City of Phoenix
 PLANNING AND DEVELOPMENT DEPARTMENT

Staff Report Z-SP-7-22-5
September 12, 2022

Proposed Use: Self-service storage warehouse, and underlying C-2 commercial uses

Location: Approximately 275 feet south of the southwest corner of 107th Avenue and Camelback Road

SP-1

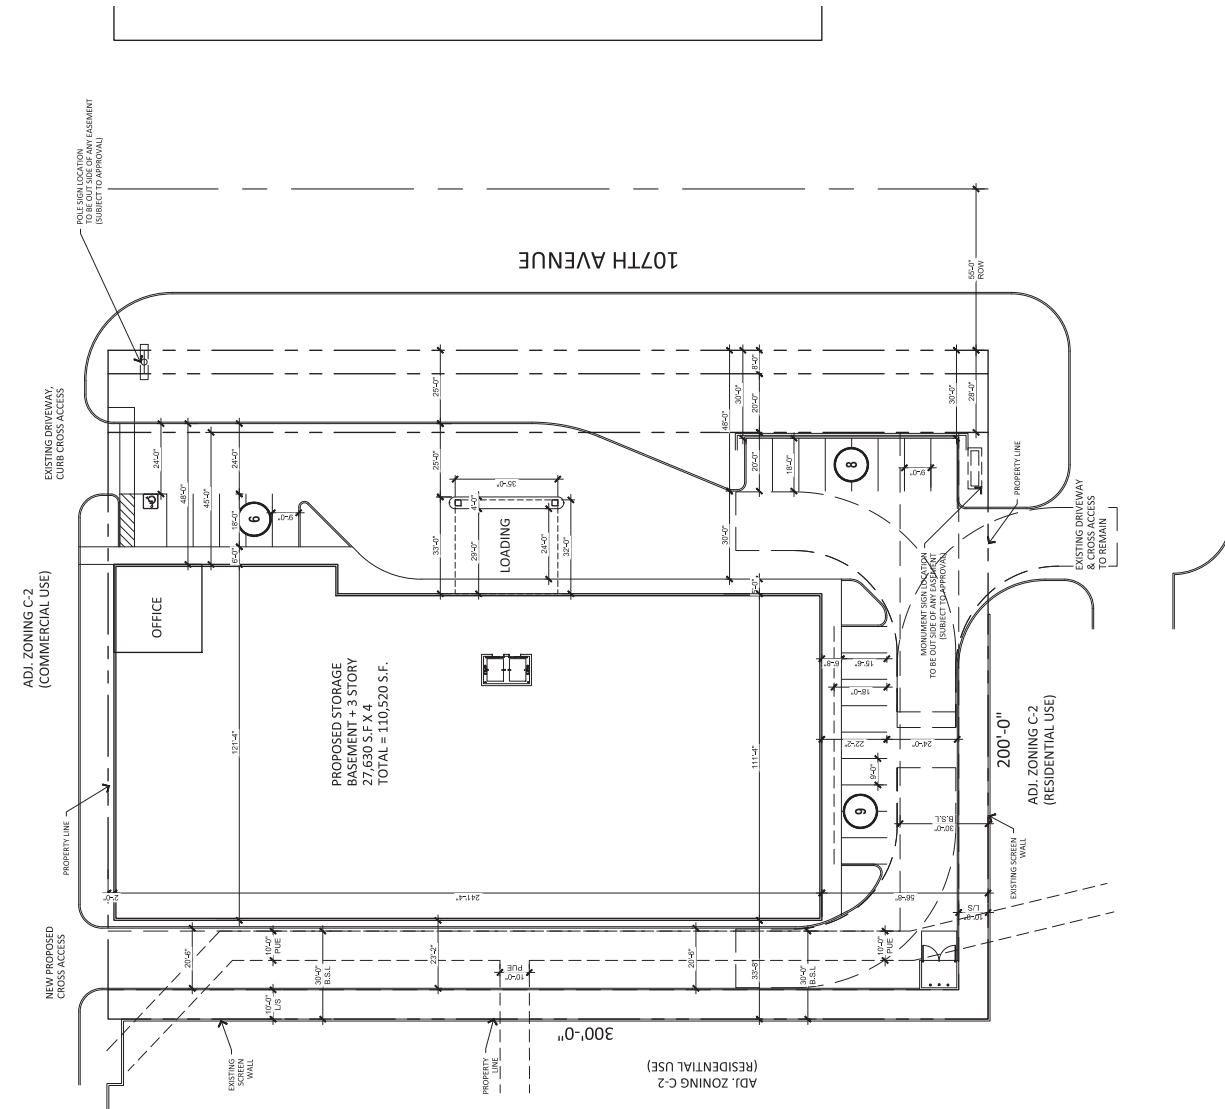
The applicant is proposing a self-service storage warehouse with a height of 32 feet and three-stories. The conceptual site plan indicates two vehicular access points will be along 107th Avenue, one located northeast of the site and the other located southeast of the site on adjacent properties. Parking areas will be located along 107th Avenue and the southern portion of the site. The proposed office will be located on the northeast corner of the proposed building. A loading area is proposed on the east side of the building. Since the loading area is visible from the frontage, staff is not recommending general conformance to the site plan.

EL-1

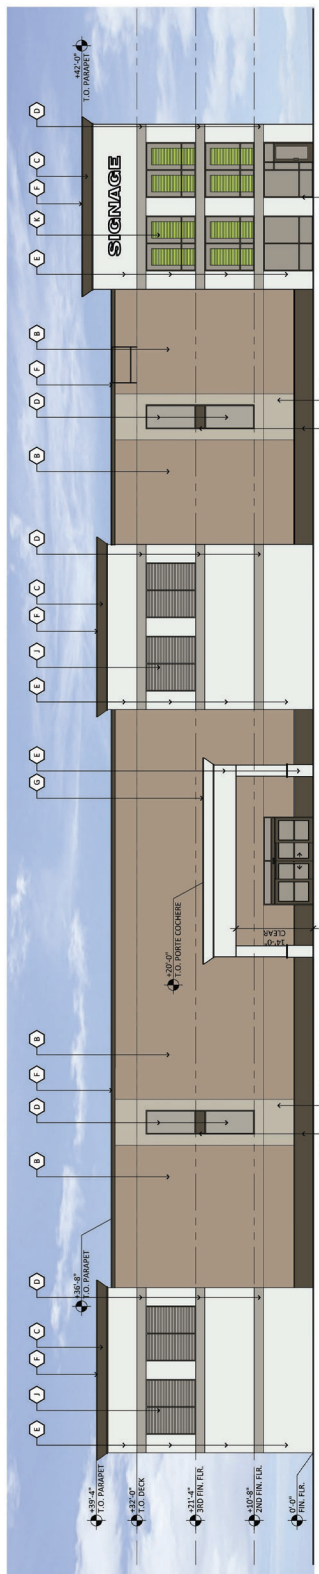
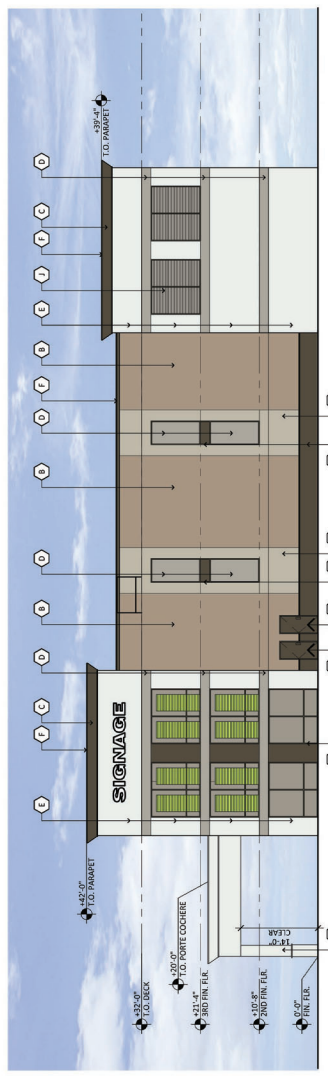
The conceptual building elevations depict architectural features that include variations in colors, building articulation, and emphasizes the northeast corner of the building where the primary pedestrian entrance is located. As a result, staff is recommending general conformance to the elevations. This is addressed in Stipulation No. 1. The subject property is also part of the Camelback Ranch PCD which has a similar architectural theme through each commercial site. This is addressed in Stipulation No. 2.

1. The development shall be in general conformance with the elevations date stamped September 1, 2022, as modified by the following stipulations and approved by the Planning and Development Department.

2. The site shall be developed with a similar architectural theme as the commercial development directly to the north. The theme should assure that building colors, elevations, exterior materials, landscaping and signage convey a sense of continuity throughout the development, as approved by the Planning and Development Department.
